JOINT REGIONAL PLANNING PANEL
(SYDNEY WEST)

JRPP No	2016SYW100
DA Number	DA/873/2015
Local Government Area	Parramatta
Proposed Development	Subdivision of proposed Lot 4 to create two (2) Torrens title lots. The site is Heritage Listed under Schedule 5 of the PLEP 2011.
Street Address	2A Darcy Road and 158-164 Hawkesbury Road, WESTMEAD
Applicant/Owner	Applicant – C Vella Owner – Western Sydney University and Trustees of The Marist Brothers
Number of Submissions	None
Regional Development Criteria	Clause 89(1)(a) of EP and A Act – Determination of Crown Development (for Refusal).
List of All Relevant s79C(1)(a) Matters	Parramatta Development Control Plan 2011, Section 94A Plan, Infrastructure SEPP, Sydney Harbour Catchment SREP, SEPP 55, SEPP 65, Urban Renewal SEPP
Recommendation	Refusal
Report by	Denise Fernandez, Senior Development Assessment Officer

Assessment Report and Recommendation Cover Sheet

S79C ASSESSMENT REPORT

Figure 4: Proposed subdivision of Lot 4 (Lot 401 and 402)

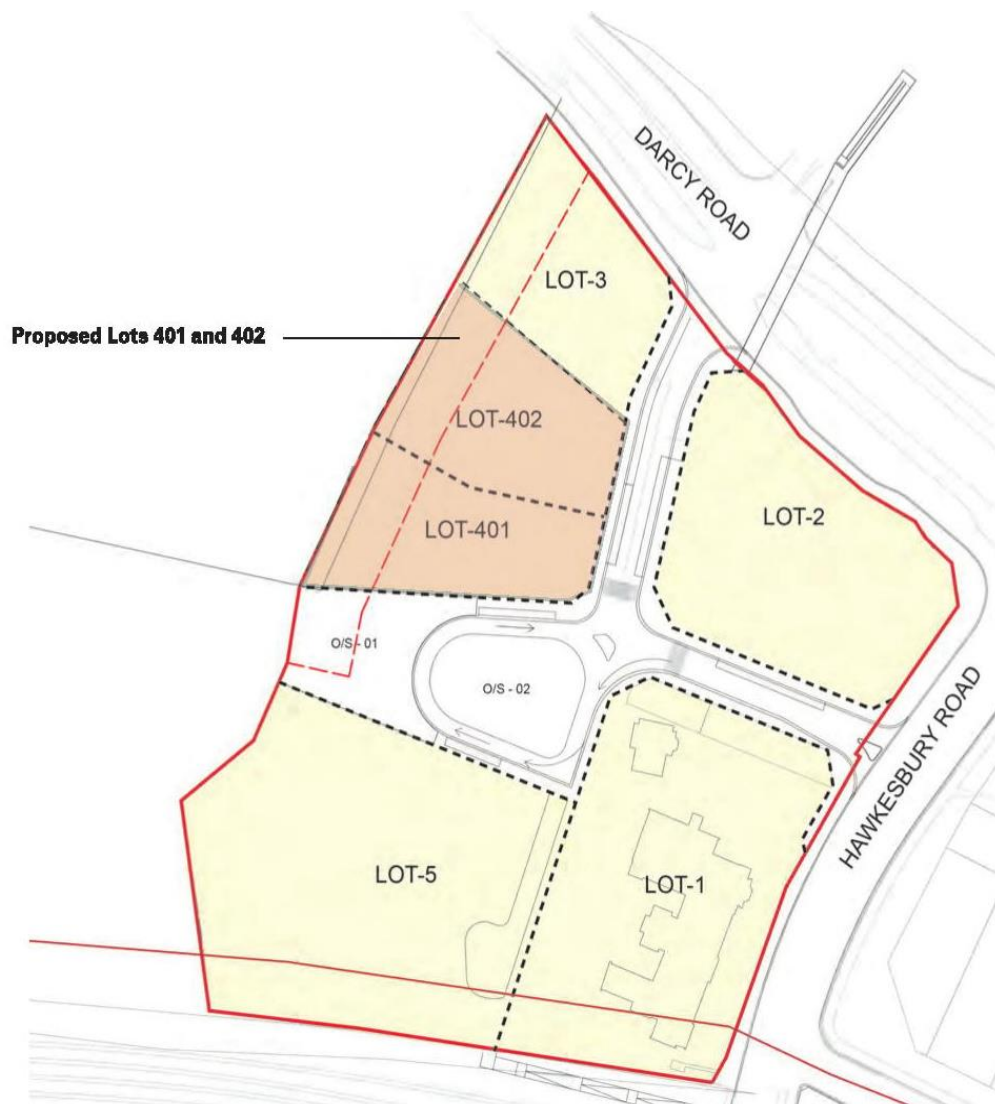
Date of Comment	Comment
8 February 2016	<p>The potential built form implications of the proposed LOT 401 & 402 subdivision appear to be as follows:</p> <ul style="list-style-type: none">• The approved FSR allowance for the subject site does not appear to be applied over each of the new subdivided areas. Instead, the individual lot FSRs reach up to 5.81:1 for proposed LOT 401 and

<p>3.17:1 for the new LOT 402. This seems to be due to the total floor area for the site from the Stage 1 DA being redistributed over the 2 new subdivided portions. This implies that yield redistribution from future development over the subject site areas is desired and a potentially taller building than anticipated might be likely over proposed lot 401 given the higher FSR.</p> <ul style="list-style-type: none"> • As a percentage of site area, more floor space is being yielded over a reduced area when we look at proposed LOT 401, while the overall yield is decreased for LOT 402. As such, it is queried whether the approved building envelopes and the corresponding heights shown are still calibrated with the new FSR distributions. It seems likely amendments to the approved building envelopes will be needed to accommodate the proposed FSR and land area splits. While the proponents have provided some sketches and diagrams within the UD report, more details are required to be satisfied the envelopes are not changing. • It is my view that at a detailed design / DA stage the future building footprints may not necessarily reflect the approved, joined, U shape pattern as most appropriate form. The resultant arrangement of open space could also become uncertain if building types and footprints change. The type of development and uses being considered on the future lots will also play a part in the form and massing of the envelopes. • Building envelope models and a reference design at 1:500 scale with efficiencies clearly stated should be provided for the proposed FSR over each of the new sites to demonstrate what types of envelopes (and uses) to expect at building DA stage. Our standard advice regarding reference design is generally as follows: <p>The reference design should addressing the following:</p> <ul style="list-style-type: none"> ○ future uses ○ public domain/ internal street network, through site links ○ vehicular access points and connections on plan, ○ street walls and setbacks and heights ○ solar and visual impact. ○ above ground car parking concepts if proposed building envelopes (including any future residential towers) – options can be provided for a range of scenarios considered by the proponent. ○ preliminary architectural concepts for typical plans and section at 1:500 showing vertical circulation, hallways, no of units/ floor, balconies etc. and conformity with the ADG. <p>For area schedules informed by the concept design noted above, GFA yield calculations should assume:</p> <ul style="list-style-type: none"> • Residential GFA = 75% of the floor plate including external walls, internal voids and balconies. • Commercial GFA = 80% of the floor plate including external walls, internal voids and balconies. • Ground floor Retail/ non-residential GFA = 33% of the floor plate including external walls, internal voids and balconies.

<ul style="list-style-type: none"> • phasing and implementation strategy. <p>It should be noted that if a U shaped form is persistent under a two lot scenario, the envelope will effectively be split if the subdivided sites develop independently of each other. This further brings into question the design, phasing and delivery of the building/ buildings and open space in between if separate developers proceed with development at different times.</p> <p>Given the FSR departure for LOT 401, after a more detailed reference design, should it eventuate that envelopes need to be changed and increased in height, then potential overshadowing needs to be considered also and updated on plans.</p>
29 February 2016	<p>Area schedules</p> <p>As a minimum, area schedules of each portion of the approved footprint being divided might clarify whether the proposed 17500sqm of GFA sought over lot 401 could be accommodated within the approved envelopes or not. The same should be done for proposed lot 402.</p> <p>One implication of the subdivision may be that once an articulated and resolved footprint for future development is designed, the future building may require more height in places as it is unlikely to simply be an extrusion of the approved master plan footprint. The concerns in the future will predominantly be the level of amenity achieved, the impact upon the public domain, overshadowing and the qualities of the architecture. The building lengths being considered by the master plan footprints could also lead to relentless street walls of residential apartments. Creating any breaks in form as a counter would reduce the GFA achieved per floor and in turn may have implications for overall development height.</p> <p>Densities</p> <p>Please be advised density over lot 401 is reaching around 5.81:1 (17500sqm of GFA over a proposed site area of 3010sqm). Whilst there are planning considerations to this, there is a question of precedent to consider and the scale of development to expect. As a comparison the Parramatta CBD strategy considers a 6:1 FSR in areas adjoining/surrounding the CBD core.</p> <p>Phasing of development / Appropriate built form outcomes</p> <p>The 12 storey blank wall issue is unresolved and appears to be an eventuality unless the footprint over the site is revisited should Lot 401 develop first/ independently following the proposed split footprint.</p>

3 March 2016	<p>In conjunction with previous advice provided and following the meeting with the proponents last week, we additionally raise concerns about the division of the communal open space and potential appropriation of communal space, in part or in whole, as POS for future units on the ground floor as a result of the proposed</p>

<p>subdivision and any interim building phasing/ boundary arrangements.</p> <p>The approved Private Domain Guidelines was supported on the basis that Lot 4 would provide a generous central communal open space for residents. Any fence or boundary division created pursuant to the subdivision would further erode the master plan and private domain guideline intent to achieve a U shaped, perimeter block / courtyard building as envisaged, with an uninterrupted and shared communal open space in between.</p> <p>Along with phasing of development concerns raised earlier (namely the potential 12 storey blank wall issue, uncertainty of development timing on lot 402 and pressure on floor plate efficiencies to keep under the approved height limits as a result of GFA redistribution) we believe the proposed subdivision will create fundamental problems for future built form to stay aligned with master plan intent. As such, given these concerns, this subdivision proposal is not supportable.</p>

- The applicant has not demonstrated that the division of the building envelope results in consistency with the approved Masterplan or results in superior design outcomes.

- It is considered to be compromised planning practice to delay modelled and tested building envelopes until the development application stage due to the uncertainty in the resulting development form which may further erode the intent of the Masterplan and create adverse amenity impacts.

- Imposing conditions of consent for example, in an attempt to treat blank walls in the interim is not supported.
- There can be no certainty that this would be a temporary arrangement to ameliorate adverse design impacts should development on Lot 401 and Lot 402 not happen concurrently and / or an integrated design manner.

- Any development on Lot 4 will set precedence in the precinct and thus should be of greater quality architecturally as an example.
- Despite Council's advice that the applicant consider revising the building envelopes for lot 401 and 402 to better reflect the intended outcomes of the Masterplan, the applicant has not provided such information.

Whilst the subject application does not propose any building works or changes to the shape of the building envelope, the proposal seeks approval to divide the U-shaped building on Lot 4 through the proposed subdivision boundary. The proposal also seeks to alter the FSR for each lot. The following assessment against some of the principles of SEPP 65 is necessary given the impact of the proposed subdivision on the building envelope envisaged under the Masterplan.

ADG design quality principle	Response
Context	The division of the U-shaped building envelope as a result of the subdivision would erode the intent of the masterplan approved under

DA/571/2014. The proposed subdivision and divided building envelope would likely result in developments with blank walls either side of the internal boundary which should be avoided particularly in a non-CBD context. As such, it is considered that the proposal does not contribute to the desired quality of the area.
Built form and scale	<p>Council does not consider that sufficient information has been submitted to support the division of the building envelope nor that this would be conducive to an equal or better design outcome for future development on either site.</p> <p>Council's Urban Designers have also reviewed the proposal and do not support the proposed subdivision and division of the building envelope for such reasons. Their detailed comments are provided earlier in this report.</p>
Landscape	Whilst the form and siting of the building envelope on Lot 4 has not changed, the landscape treatment within the common open space area is compromised as a result of the subdivision. The proposal will require a boundary fence to segregate the landscaping treatment on the ground floor. The approved Private Domain Guidelines envisage that the ground floor courtyard area would be treated holistically. The proposed subdivision is contrary to this intent.

Amenity	<p>Council's Urban Designers notes that as a result of the proposed subdivision, the amenity will be compromised. In particular the potential division and appropriation of the communal open space is a poor outcome as a boundary fence will be required to separate Lot 401 from Lot 402.</p> <p>Further, Council does not believe that sufficient information has been submitted that future development on either lot will achieve adequate internal amenity, solar access and quality architecture.</p>
Social dimensions/housing affordability	Insufficient information has been received that supports a building envelope on each lot that would allow for additional housing choice within the area.
Aesthetics	<p>Phasing of the development upon approval of the subdivision envisages blank walls until such time as the adjacent lot is developed. Whilst these blank walls may be treated in the interim, it is not considered to be the best design solution for a greenfield site that is not in a CBD location.</p> <p>The practicality of the subdivision is questionable and would likely impact internal layout and amenity.</p>

The divided building envelope provides a 12 metre setback to the central boundary and a 24 metre building separation to the opposite arm of the U-shaped building. Whilst this arrangement has not changed from the approval under DA/571/2014, Council does not consider that sufficient information has been received that supports quality development on either lot once subdivided and an articulated building form is realised. That is, in concept, it appears that the minimum building separation is provided. However, the documentation provided has not considered balcony locations and whether the internal floor layout is acceptable in terms of area, amenity and utility. On this basis, Council cannot support the application.

Under DA/571/2014, it was understood that there would be a central communal open space area on Lot 4. However, as a result of the proposed subdivision, the location, amount, access and quality of the communal open space will be compromised.

The simplistic approach to divide the building envelope on Lot 4 is not considered to be an appropriate response to the proposed subdivision. A satisfactory design analysis has not been submitted. The uncertainty in the built form once buildings are modeled and tested may result in additional impacts to solar access to the development, adjoining sites and any communal open space.

1. Council has not received sufficient information to allow an assessment of the proposed subdivision and building envelopes on Lot 401 and Lot 402.
2. Without a satisfactory design analysis to support the proposed subdivision and division of building envelopes, the quality of future development on Lot 401 and 402 is uncertain.

3. As insufficient information has been received, the proposal fails to satisfy the design principles of SEPP 65 namely, context, built form and scale, landscape, amenity, social dimension and aesthetics. In addition, Council's Urban Designer objects to the proposal and does not consider the subdivision to be satisfactory.

4. The applicant has failed to demonstrate that the division of the building envelope on Lot 4 will achieve the objectives and comply with the design controls pursuant to the Apartment Design Guidelines, in particular, the provision of appropriate building separation, solar access, communal open space, private open space and communal open space.

5. The FSR for Lot 401 results in departures to the approved FSR under the Masterplan and further encroaches on the maximum standard under PLEP 2011. The applicant has not in this case demonstrated rationale to depart further from the LEP and above the Masterplan without satisfactory testing the bulk, scale and amenity impacts through a design analysis. As such, the Clause 4.6 variation submitted by the applicant is unacceptable and unsupportable.

7. The proposal to subdivide Lot 4 into 2 smaller allotments is inconsistent with the urban design objectives and intent of the Masterplan that were approved under DA/571/2014 and is therefore not in the public interest.
